Product Change Notification

Change Notification #: 112692 - 00
Change Title: Intel® Server System R1208BB4DC
PCN 112692-00, Product Design
Update System PSU Bracket
Date of Publication: November 06, 2013

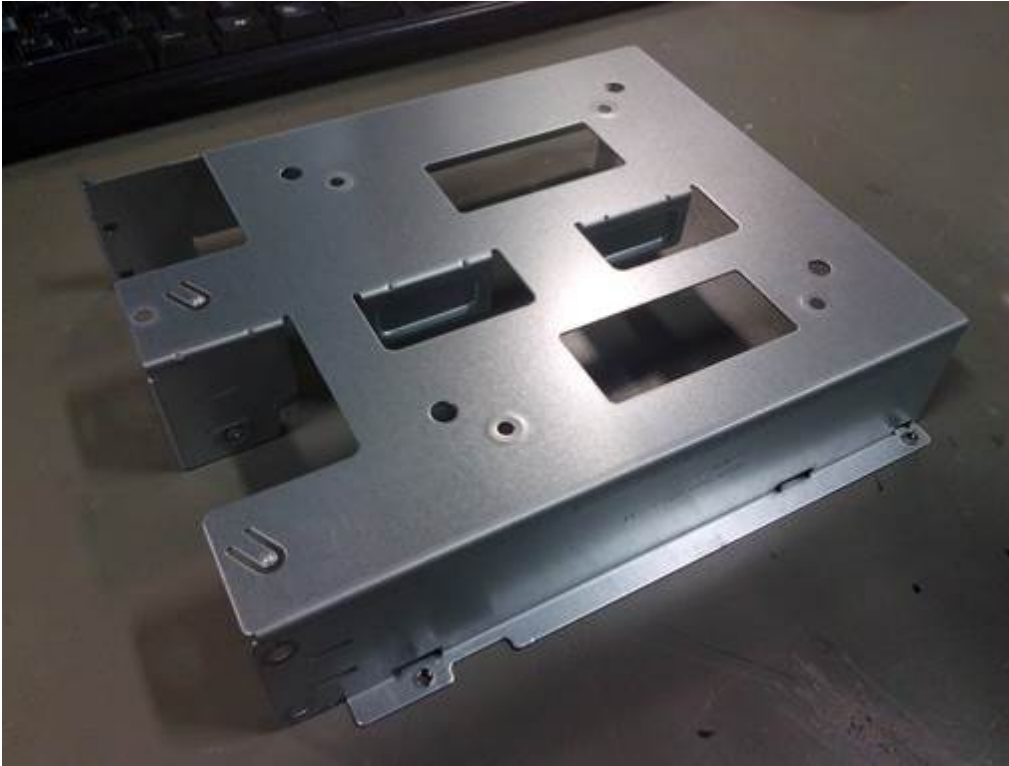
Update the Power Supply bracket to remove middle punch. Please refer to below pictures for details:
